## PT1KCON Connector Wiring Assignment Change

**PT1KCON Connector**

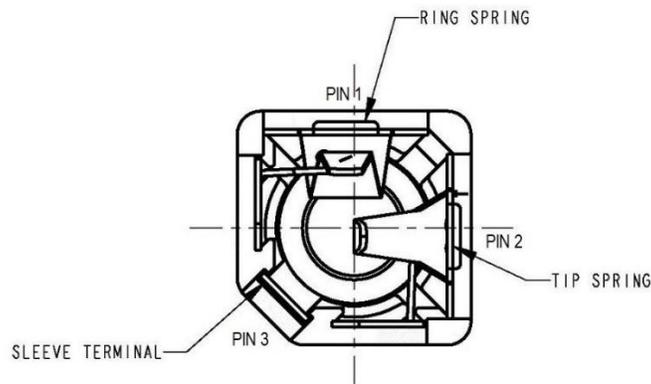
If you had purchased our SMD-200 w/ PT1KCON connector, WSD-SMD-A(KIT-SMD) or SMK101(KIT-SMK101) control panel before August 2020, please modify the wiring on the PT1KCON for our new PT1000 sensor.

Old wiring assignment: PIN 3 to Terminal 11, PIN 2 to Terminal 10 or 12, PIN 1 is for ground (enclosure). This wiring assignment can only be used with our old style PT1000 sensor.

New wiring assignment: PIN 1 to Terminal 11, PIN 2 to Terminal 10 or 12. This new wiring assignment can be used for both old style and new style sensors.

**Cabin Sensor (New Version)**

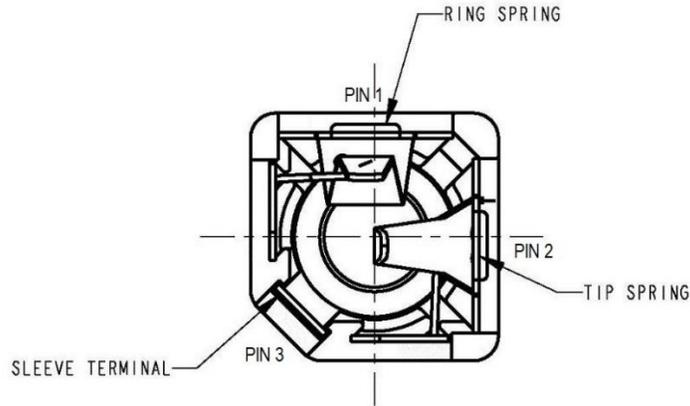
The old version sensors have white Teflon cable and 2-Pin 6.35mm phone jack connector (only one black ring on the connector tip). While our new sensor comes with stainless steel cables and stereo 3-Pin 6.35mm phone jack connector (two black rings on the connector tip).
